TO: Planning Board
Zoning Board of Appeals
Design Review Board

RE: Grocery Store at Meadow Walk Site Plan – National Development
526/528 Boston Post Road

DATE: December 4, 2015

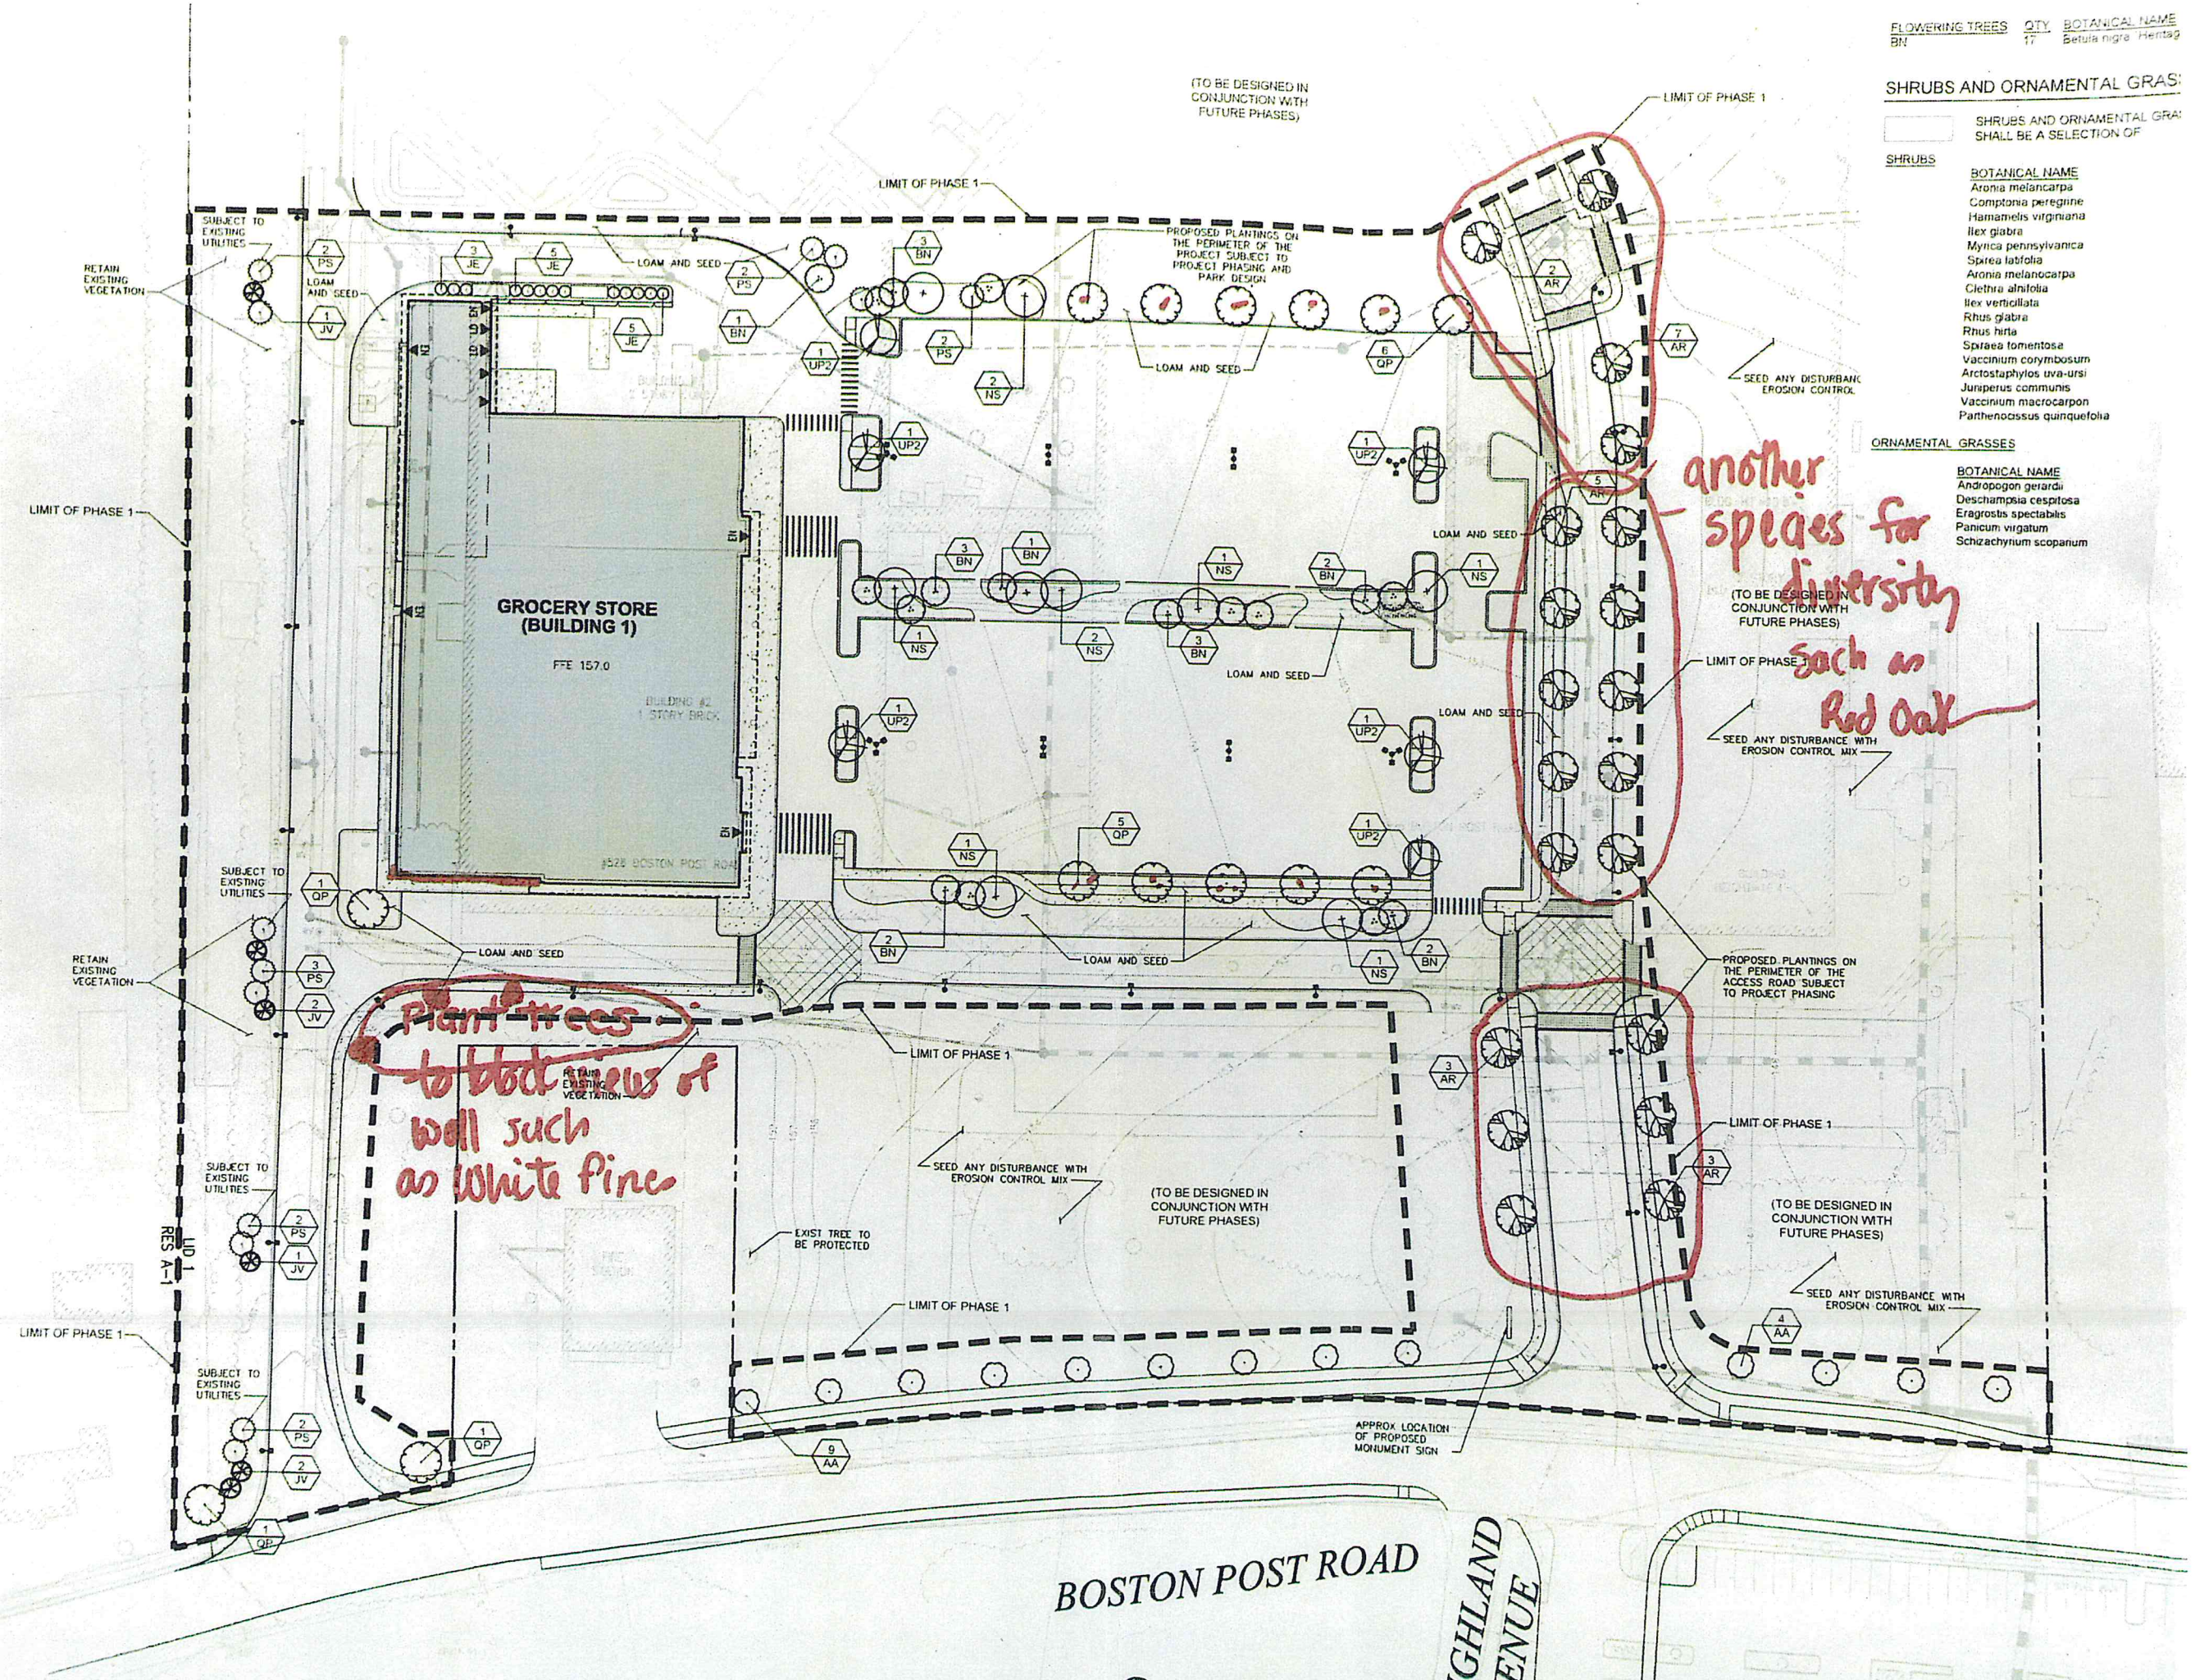
The Board met to review the Proposed Landscape Design for the Whole Foods/National Development site at 526 & 528 Boston Post Road and has the following recommendations (see attached notes on the site plan):

- 1) Regarding the 20 red maples lining the main entrance, the Board would like to see more diversity for both aesthetic and disease-prevention purposes. (planting 20 of the same species together could be risky if one tree gets diseased, they could all be lost at once). The Board recommends 3 groupings of trees: 6 red maples at the start, 10 red oaks in the center and 4 of another species at the end of the drive)

- 4) The Board is further concerned that there is a disproportionate number of pyramidal shaped trees and that they would not provide enough shade for cars and sidewalks.

Plant trees to block views of wall such as white pine
